Substantive response of the Local Highway Authority to a planning consultation received under The Development Management Order.

Planning Application Number: 24/00657/FUL

Application Address: Barnhills Farm Merrylees Road Thornton Coalville Leicestershire LE67 1AP

Description of Application: Re-consultation. Erection of two storey childcare facility with ancillary services and associated external play areas and animal interaction areas.

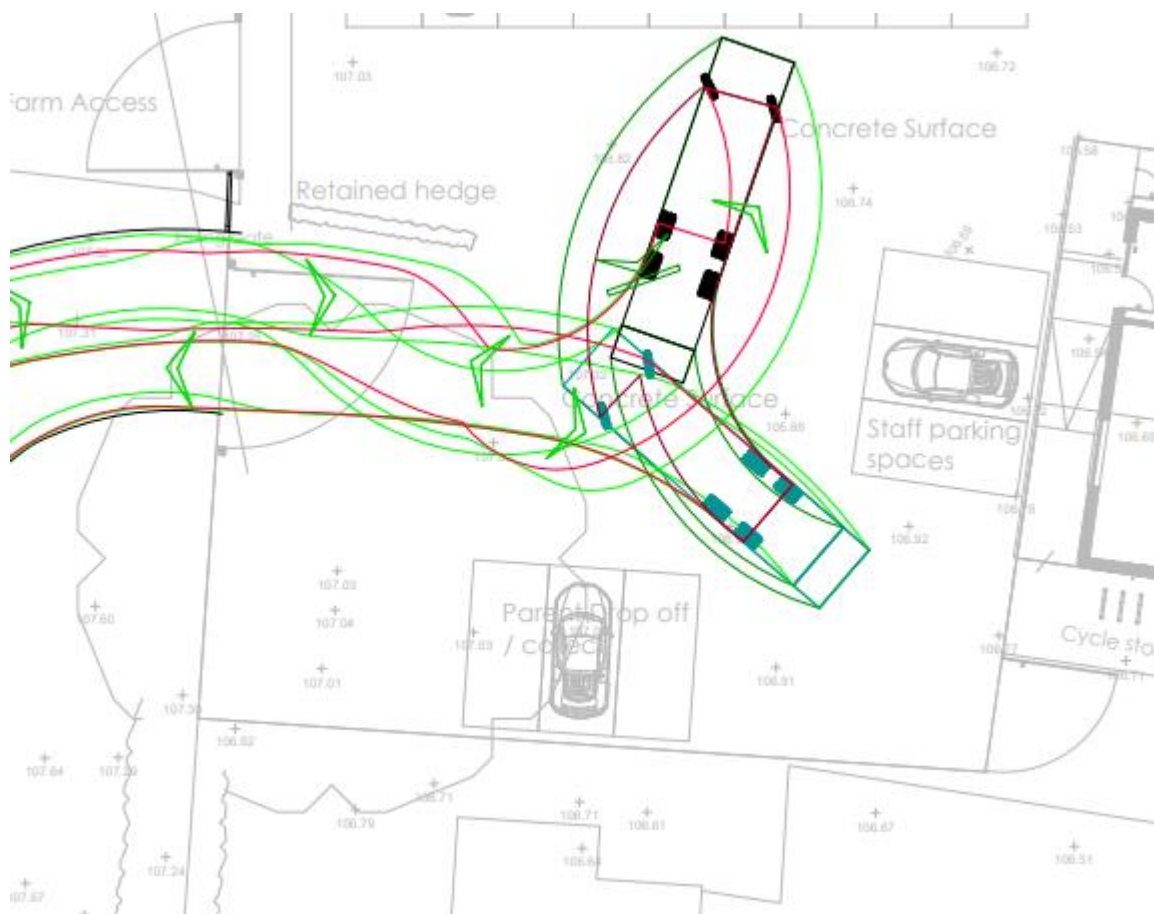
Notwithstanding the above, the LHA has reviewed both Swept Path Analysis (Layout) drawing number RHC-24-155-03 revision B and Swept Path Analysis (Farm Vehicle) drawing number RHC-24-155-04 revision B. Both drawings indicate that the vehicles would conflict with the proposed access gate, proposed Kissing gate and encroach on to the PROW as shown on figures 1 and 2 below which raises concerns over highway safety.

Given the above, the Applicants are required to provide a revised SPA which addresses the above concerns.
